REMARKS

TITLE: PACING AND SENSING VECTORS
INVENTORS NAME: Jeffrey E. Stahmann et al.
SERIAL NO.: 09/779,754

Fig. 2

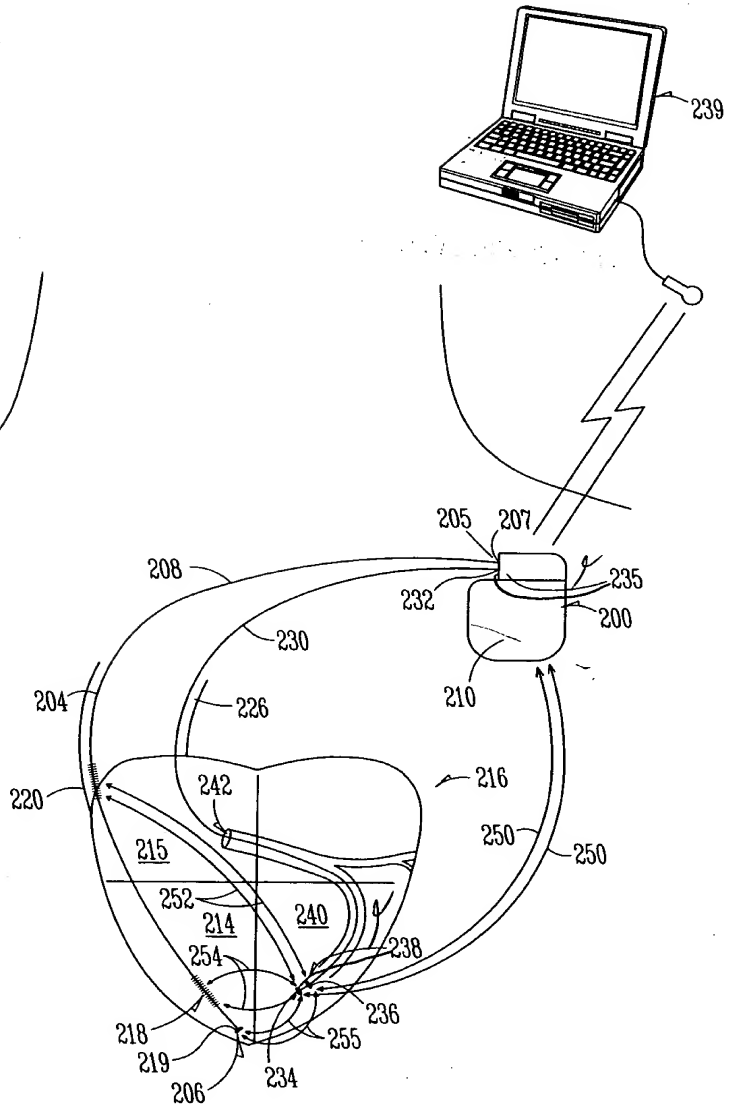
The drawings were objected to under 37 C.F.R. § 1.84(p)(4). The Office Action asserts that, in Figure 2, reference characters "207" and "235" designate the same part. Applicant traverses this assertion, but submits a clarifying drawing change. The patent application uses reference character 207 to refer to a lead connector at a proximal end 205 on a first lead 204.

(See Application at page 7, lines 23-24). The patent application uses reference character 235 to refer to a lead connector at a proximal end 232 of a second lead 226. (See Application at page 8, lines 27-29). Applicant believes that this drawing change reflects (and is fully supported by) the specification of the present patent application. Accordingly, Applicant requests withdrawal of this objection.

The Office Action also asserts that, in Figure 2, reference characters "236" and "238" are not clearly marked. Accordingly, Applicant submits a clarifying drawing change. The patent application uses reference character 236 to refer to a first electrode, and uses reference character 238 to refer to a second electrode that may be more distal than the first electrode 236, such as at the distal end 234 of the lead 226. (See Application at page 9, lines 3-10). Applicant believes that this drawing change reflects (and is fully supported by) the specification of the present patent application. Accordingly, Applicant requests withdrawal of this objection.

Fig. 3

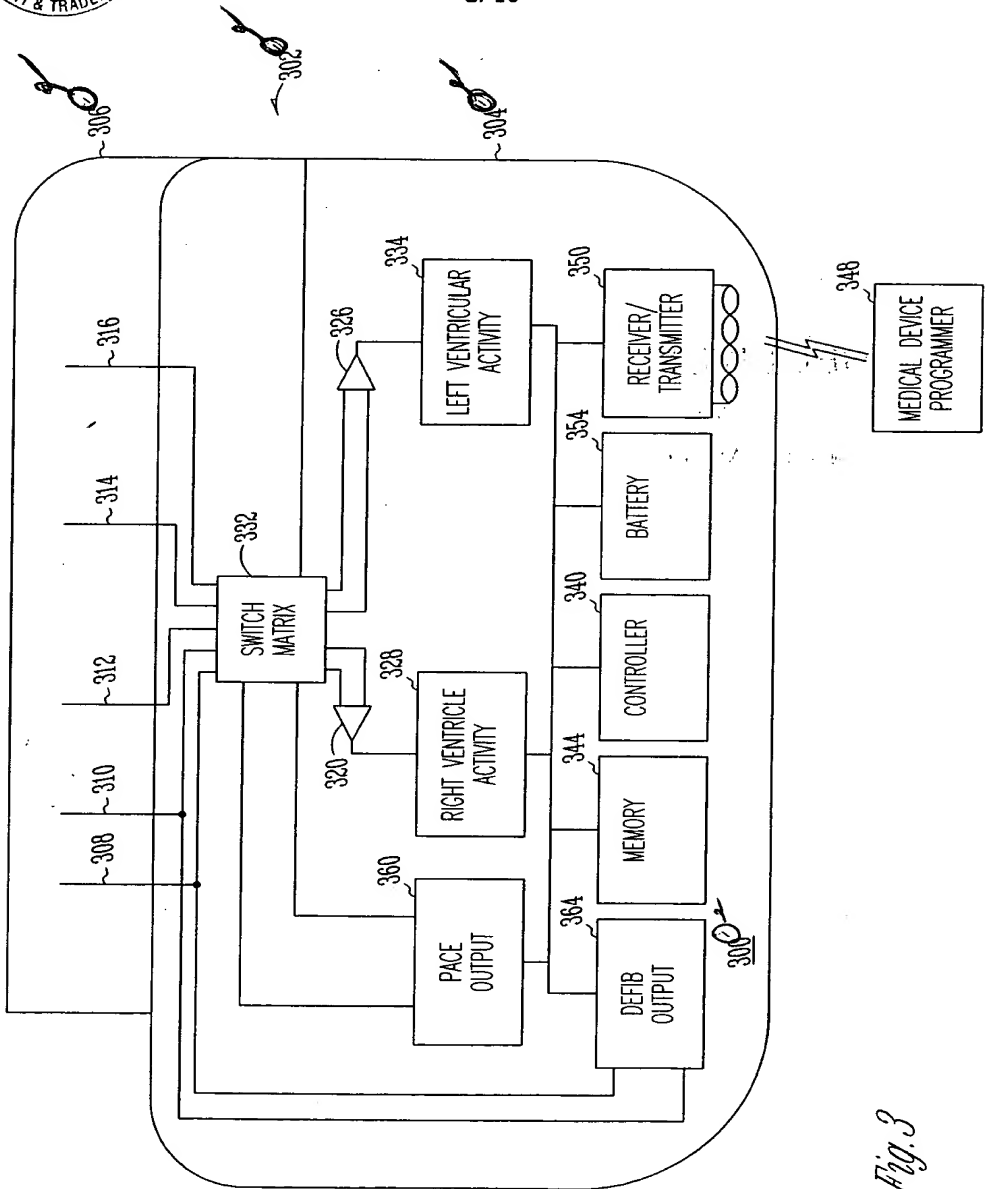
The Office Action also asserts that, in Figure 3, the reference elements 300', 302', 304', and 306' are not mentioned in the description. Accordingly, Applicant submits a clarifying drawing change that removes the "prime" designation on these reference numerals such that they are consistent with (and fully supported by) the specification of the present patent application. Accordingly, Applicant requests withdrawal of this objection.
